**RFI 098
Pebble Project EIS**

Title/Subject:	TSF Options, Mine Area
Requestor:	AECOM
Date Transmitted:	10/16/2018
Recipient:	Pebble Limited Partnership (PLP)
Response Requested by:	10/22/2018
Rationale:	The PLP response for RFI 069 presented 26 potential TSF locations that were considered near the mine area. Details on feasibility and environmental considerations for these locations are necessary for alternatives screening purposes and for the USACE to evaluate the Least Environmentally Damaging Practicable Alternative (LEPDA).
Describe the Information Requested and Level of Detail:	<p>Please provide an evaluation of each mine area TSF location that was considered and explain why the NFK West and NFK East locations were ultimately selected. Include:</p> <ul style="list-style-type: none"> • Feasibility (technology, economics, logistics, common sense) • Availability (both now and ten years ago during project planning) • Environmental impacts (wetlands/Waters of the US, miles of streams, habitat, fill, dam safety, etc.)

The question presented in RFI 098 on TSF options in the mine area is addressed below:

TSF OPTION 13

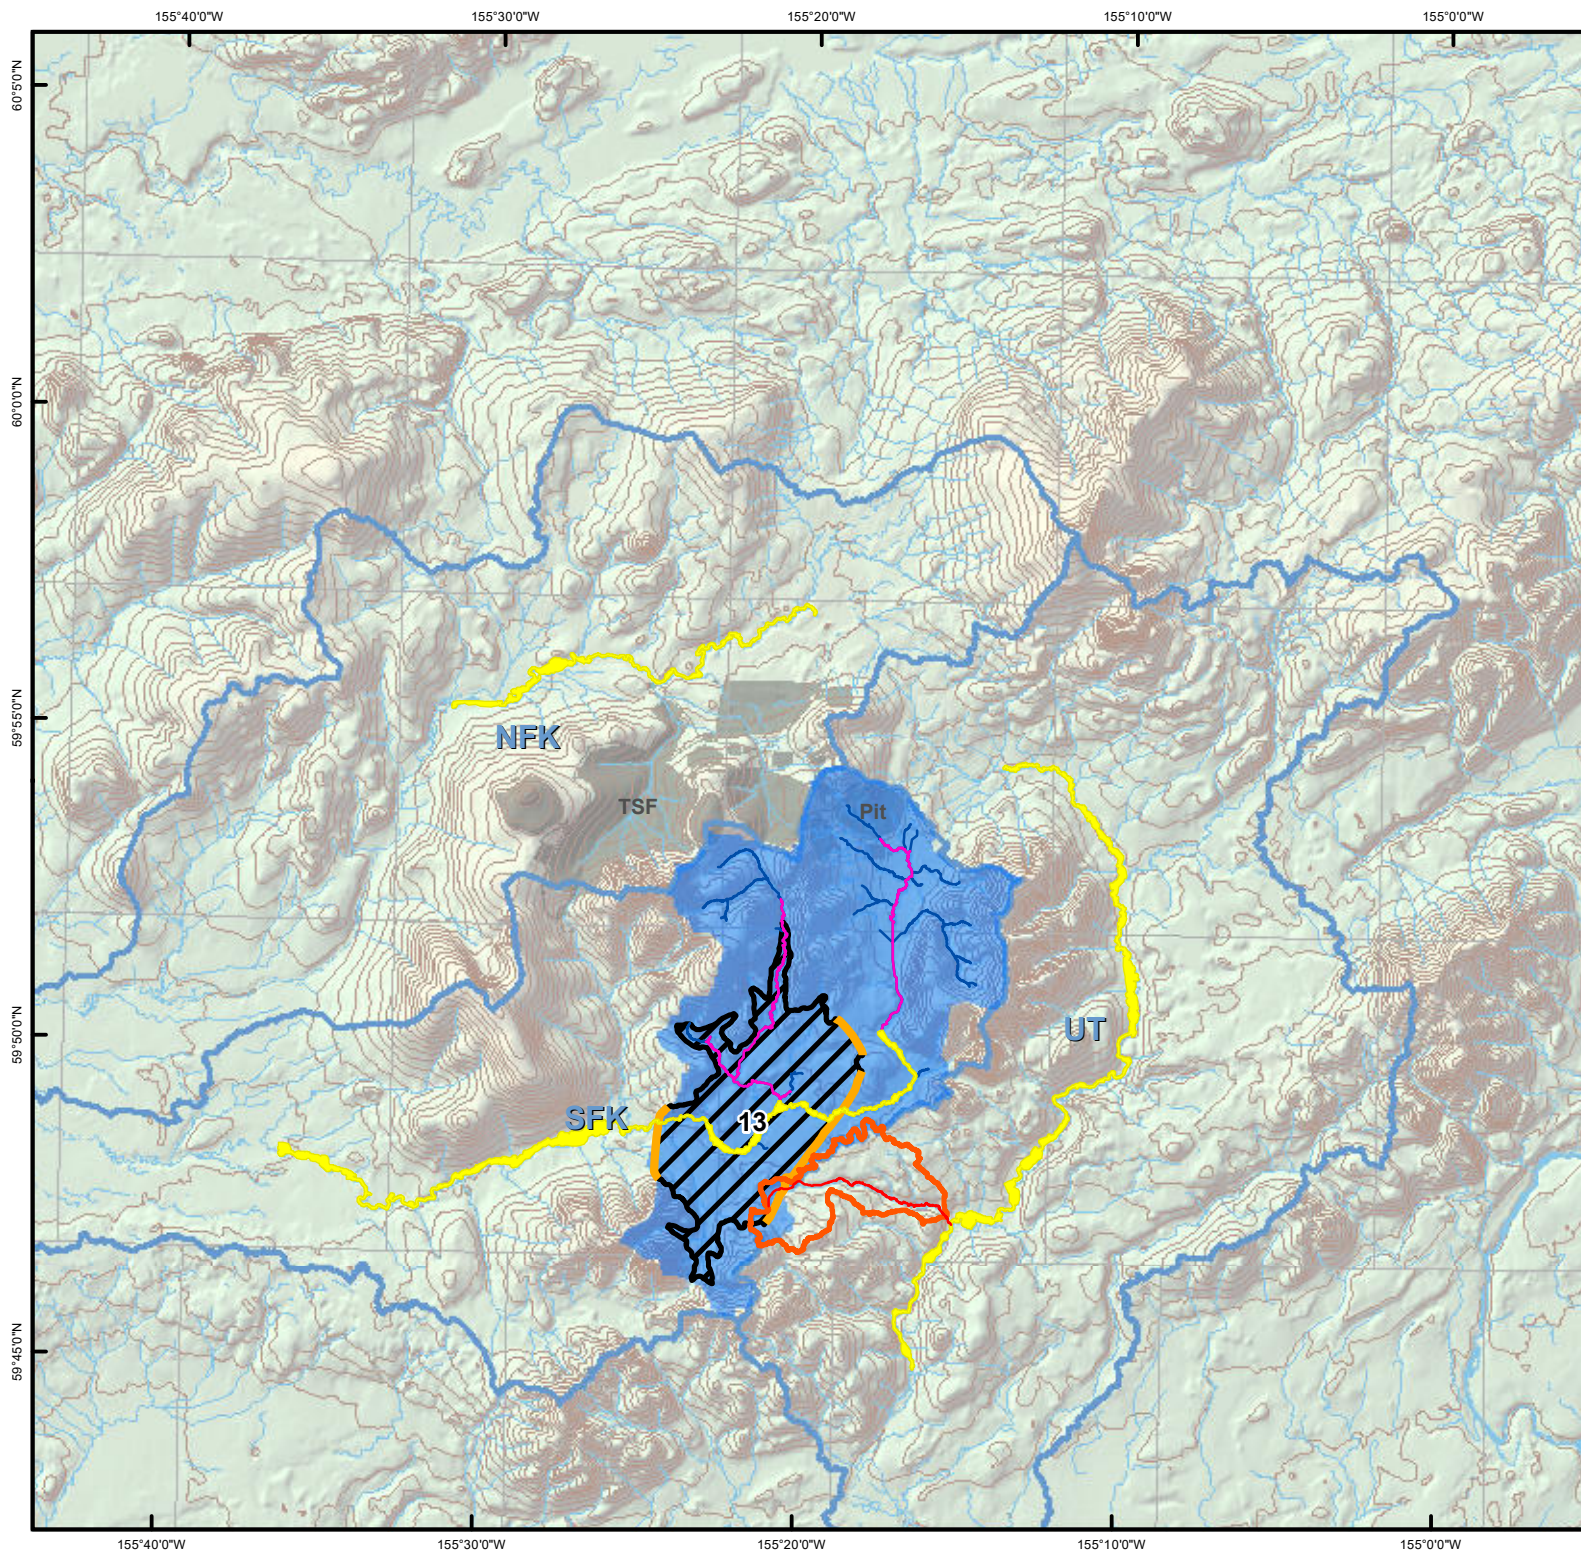
Option 13

- Fills less mapped wetlands but has a much larger overall footprint and fills more than two times as many stream miles.
- The impacted drainage basin and impacts to fish-bearing and anadromous streams are significantly higher.
- Embankment location precludes effective collection of seepage from a flow-through embankment and would have the potential to impact groundwater flows into the SFK and UTC 119A drainages.
- The footprint has extensive overlap with MCO393.

TSF OPTION 14

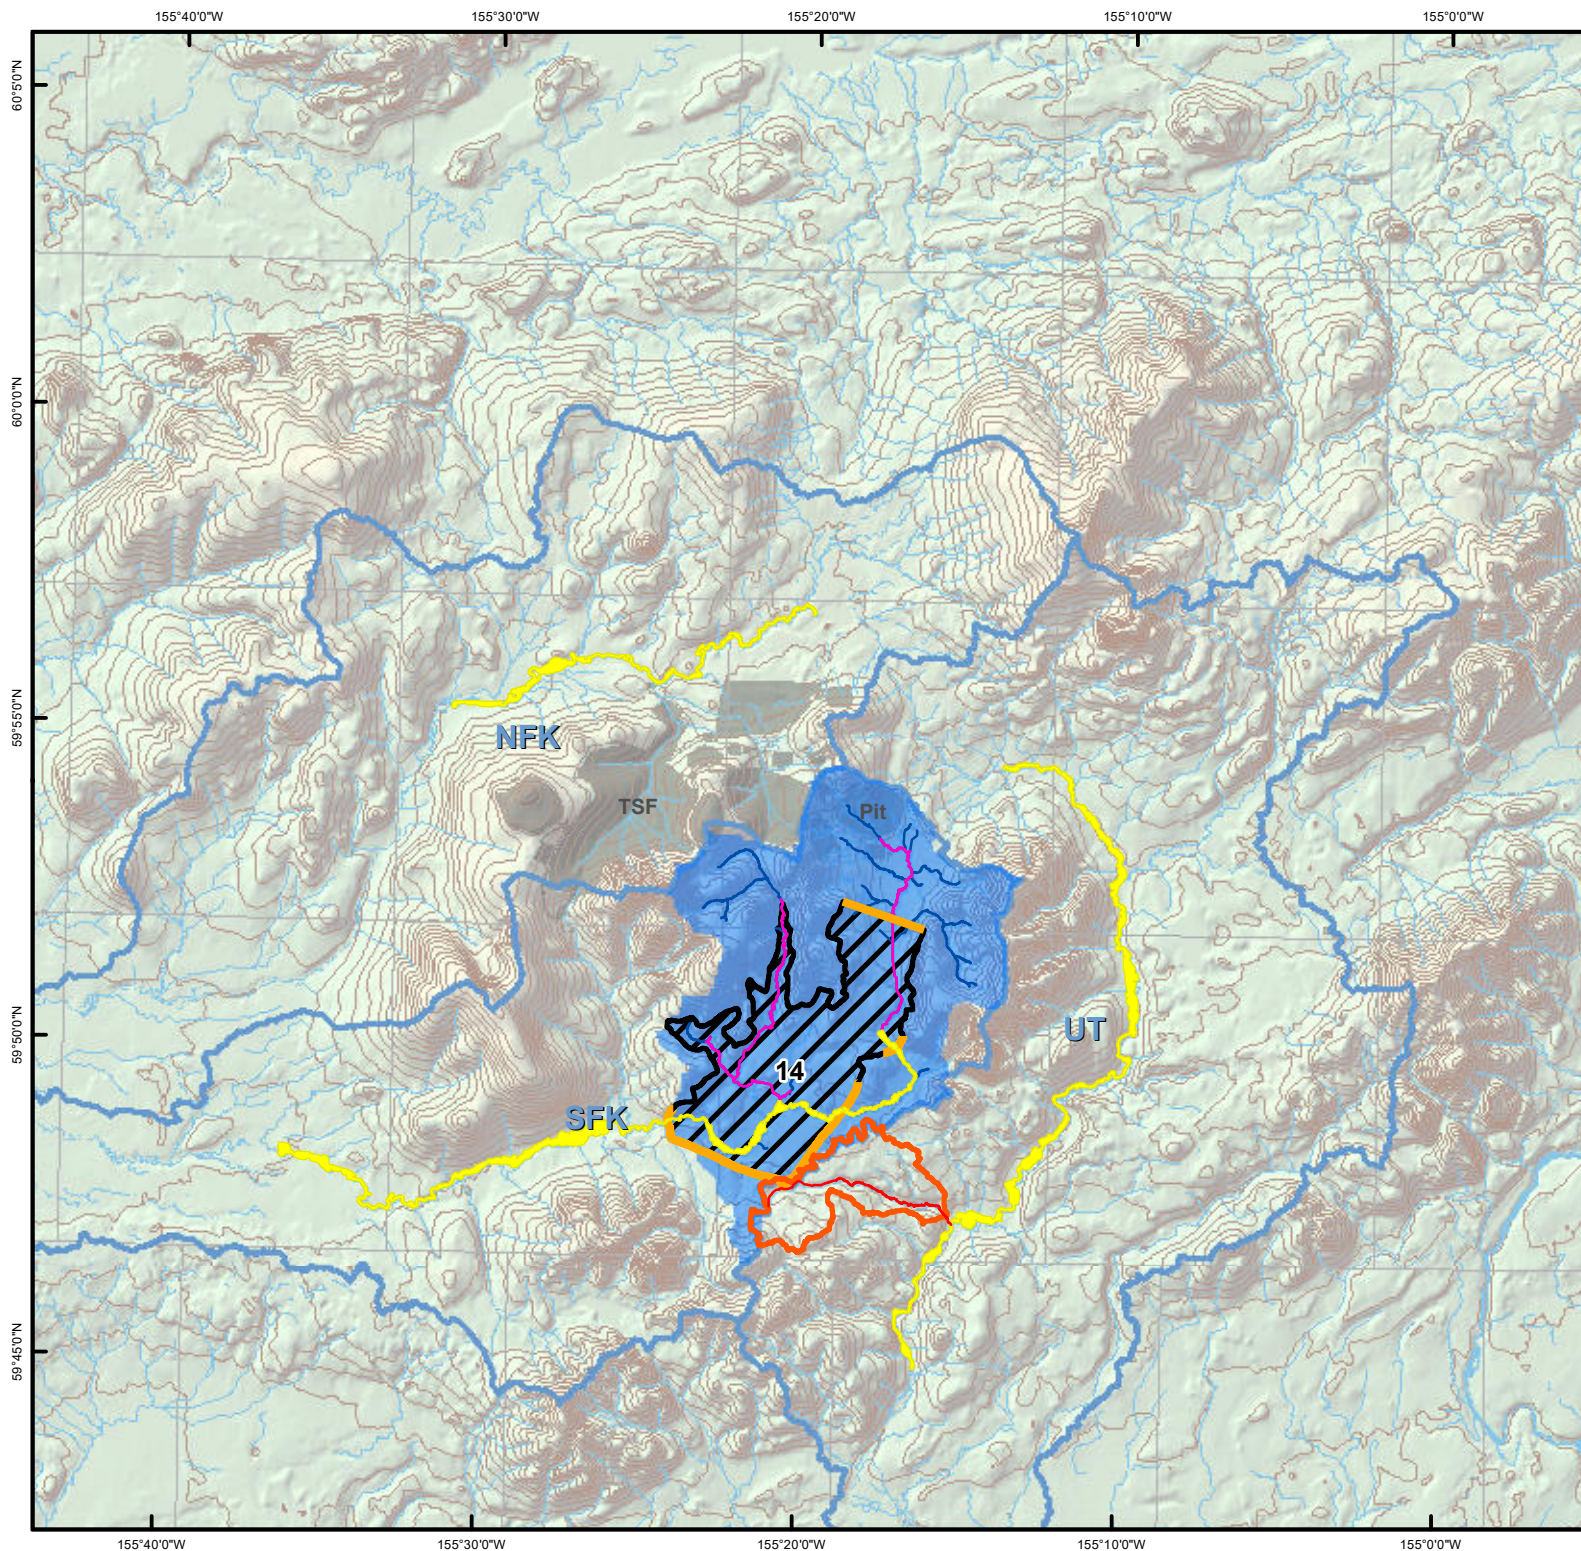
Option 14

- Fills less mapped wetlands but has a much larger overall footprint and fills more than two times as many stream miles.
- The impacted drainage basin and impacts to fish-bearing and anadromous streams are significantly higher.
- Embankment location precludes effective collection of seepage from a flow-through embankment and would have the potential to impact groundwater flows into the SFK and UTC 119A drainages.
- The footprint has extensive overlap with MCO393.

TSF OPTION 15

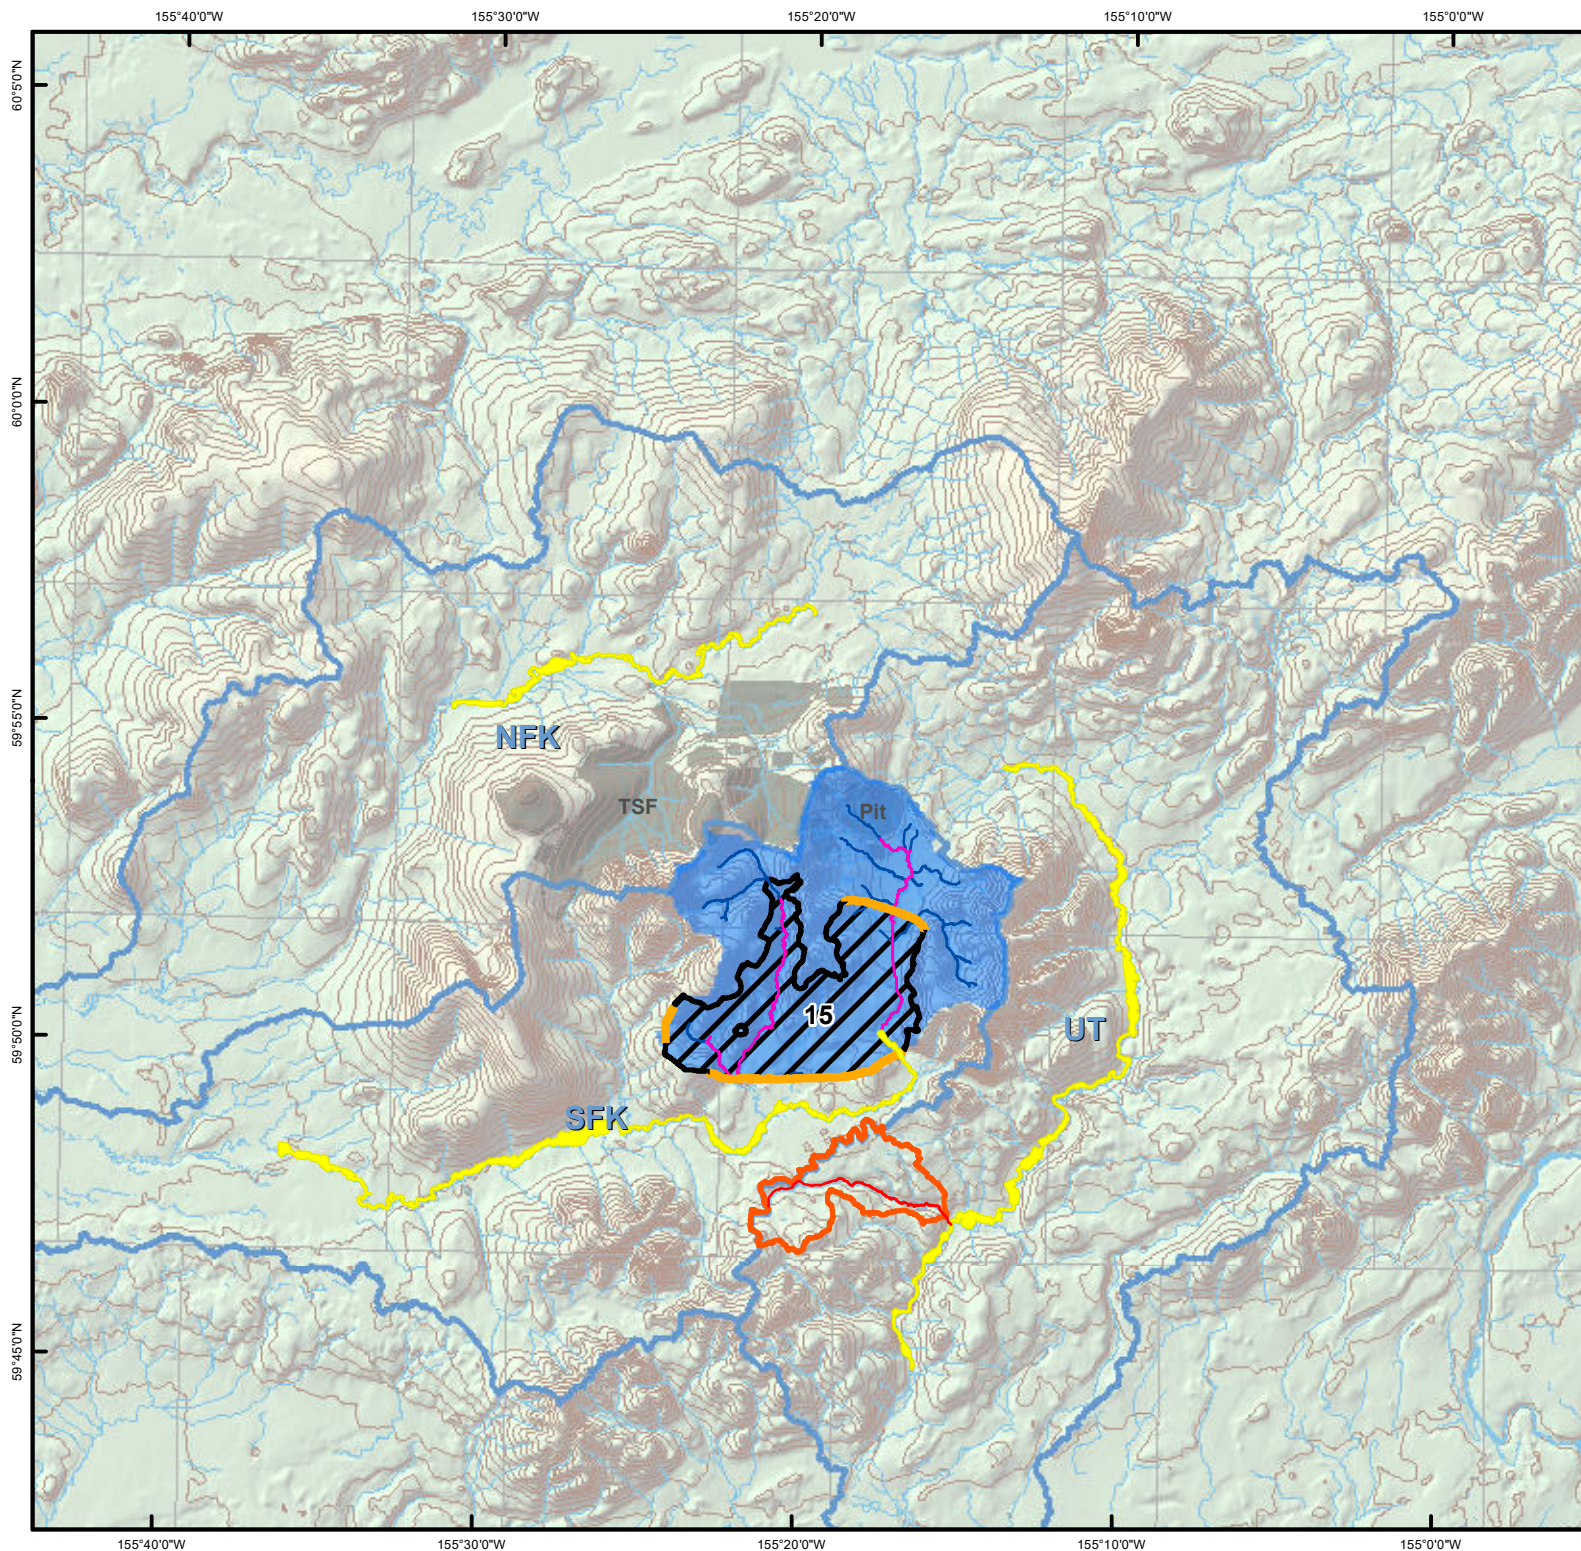
Option 15

- Fills less mapped wetlands but has a larger overall footprint and fills nearly two times as many stream miles.
- The impacted drainage basin and impacts to fish-bearing and anadromous streams are significantly higher.
- Embankment location precludes effective collection of seepage from a flow-through embankment and would have the potential to impact groundwater flows into the SFK and UTC 119A drainages.
- The footprint has extensive overlap with MCO393.

TSF OPTION 16

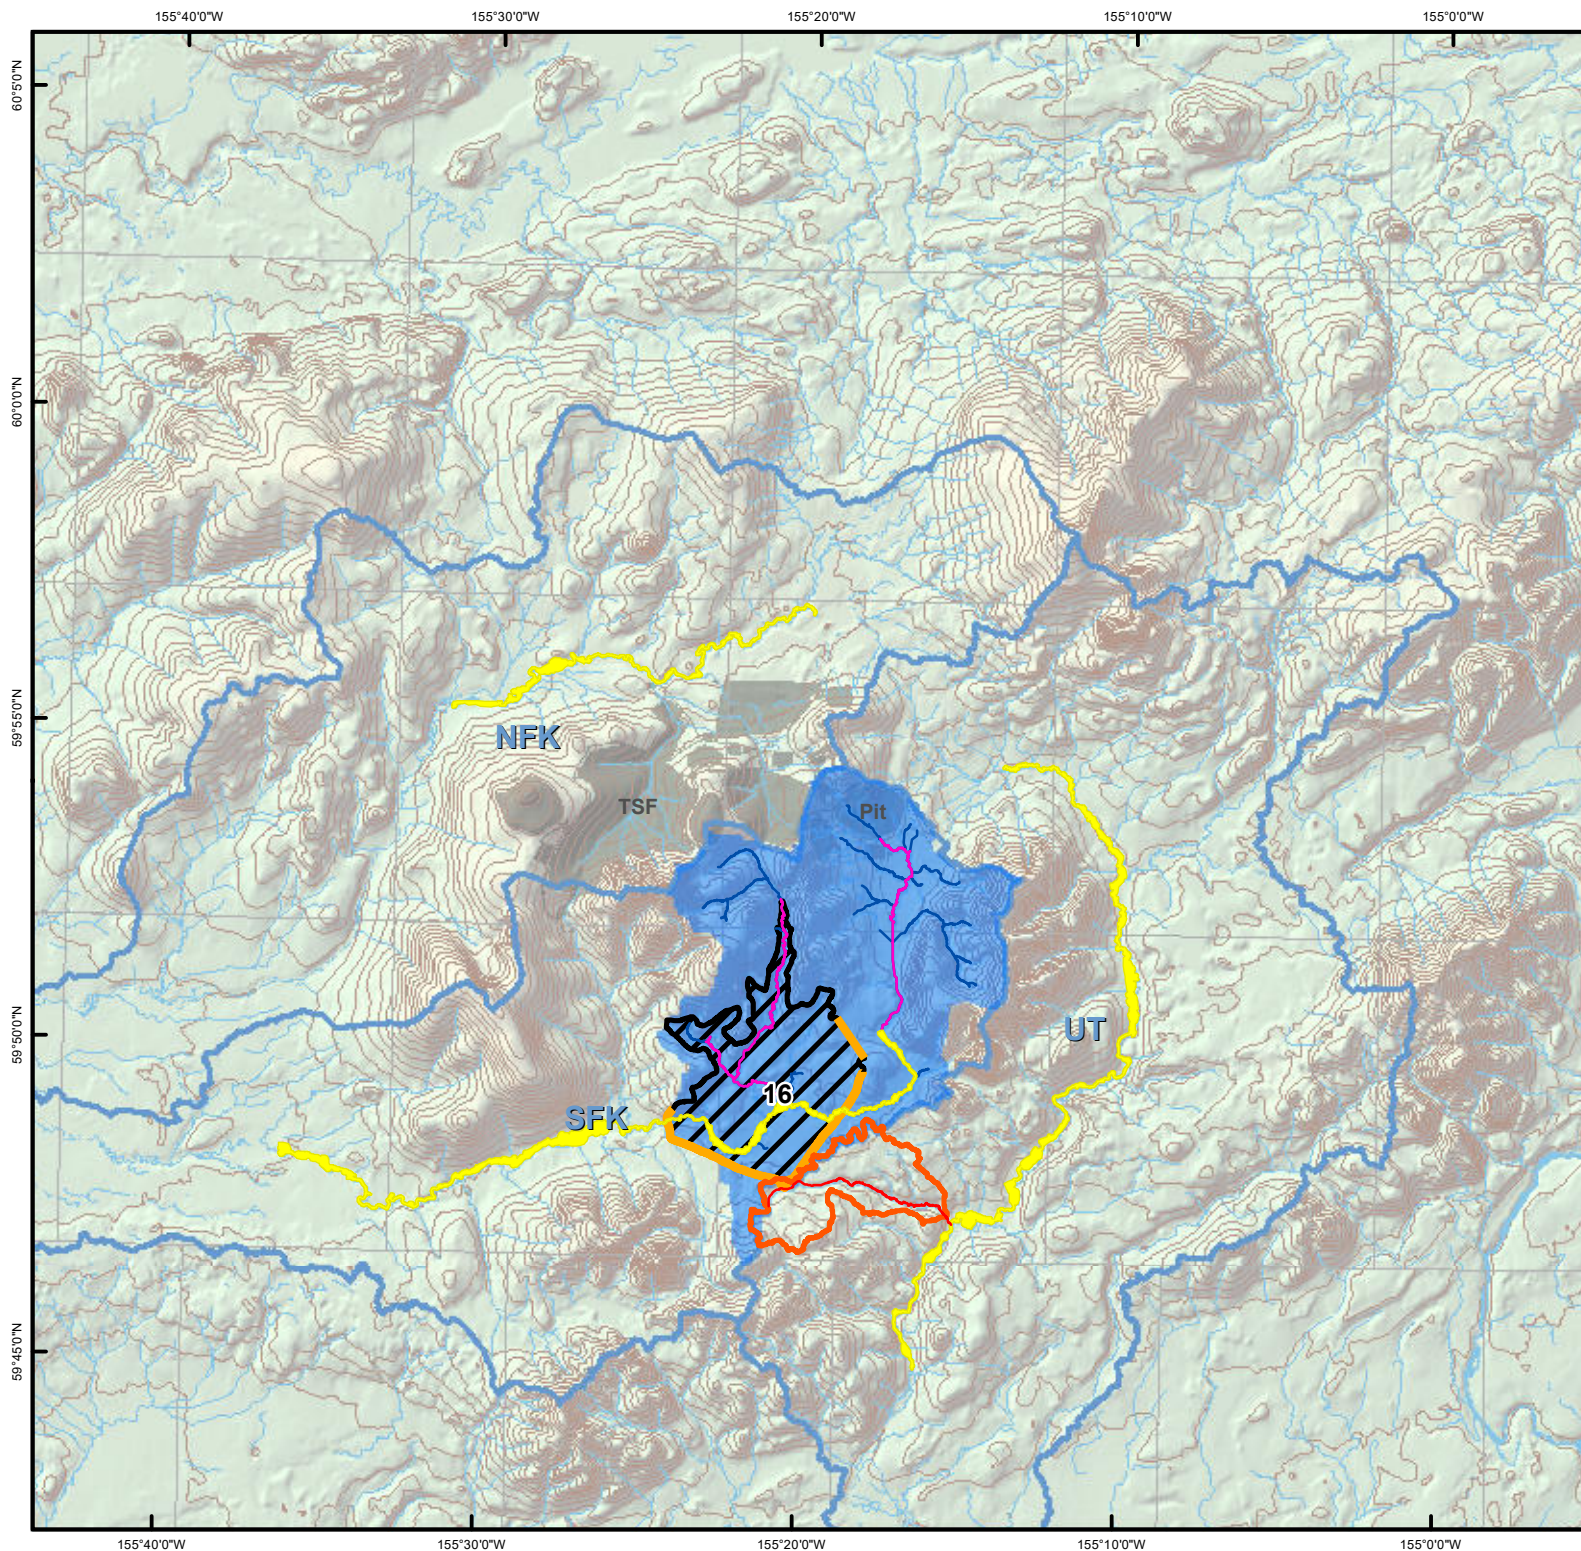
Option 16

- Fills less mapped wetlands but has a larger overall footprint and fills nearly two times as many stream miles.
- The impacted drainage basin and impacts to fish-bearing and anadromous streams are significantly higher.
- Embankment location precludes effective collection of seepage from a flow-through embankment and would have the potential to impact groundwater flows into the SFK and UTC 119A drainages.
- The footprint has extensive overlap with MCO393.
